**Subdivision 2006S-316U-07**  
**Boyce Subdivision**  
24 - Summers  
9 - Warden  
May B. Smith Boyce et vir, owners, and H & H Land Surveying, surveyor.

## Metro Planning Commission Meeting of 2/8/2007

**Jocelyn Hills, Section 1**  
**2006S-371U-07**  
23 – Evans  
9 - Warden  
Allen Cargile, owner/developer and Campbell, McRae and Associates, surveyor.  
*Deferred from the January 25, 2007, Planning Commission Meeting.*

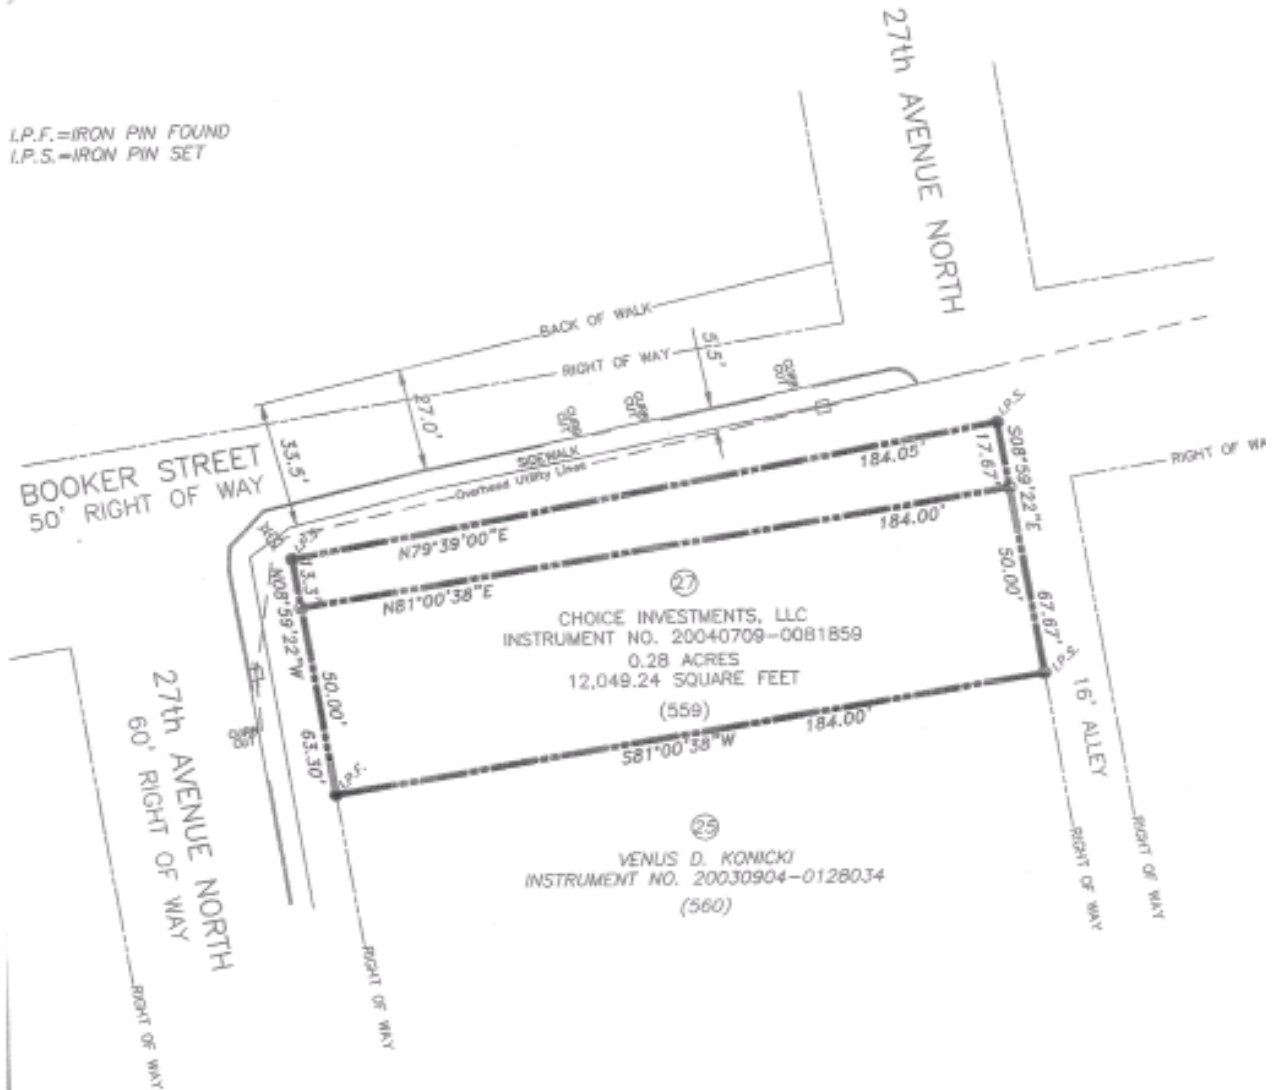
In addition, the applicant’s survey does not appear to accurately represent the existing conditions in this location. The survey labels Booker Street as having 50 feet of right of way, but Metro’s GIS maps show the existing right of way as only 40 feet wide. This is an important distinction because the requested abandonment apparently will result in an even narrower remaining right of way than is shown on the applicant’s survey. The widest portion of the property sought to be abandoned is 17.67 feet wide. If abandoned by Metro, this would result in mapped right of way in this location of less than 23 feet.

The following departments or agencies have reviewed this request: Metro Public Works and Emergency Communications recommend approval. Metro Water Services recommends **disapproval** because an 8" sanitary sewer line is located within the property sought to be abandoned.

Staff recommends **disapproval** of this right of way abandonment because the remaining right of way, if the property is abandoned, would be substandard and not sufficient for a normal street section, including sidewalks and a planting strip. Staff also recommends disapproval because Water Services has noted that an 8" sanitary sewer is located within the property sought to be abandoned.
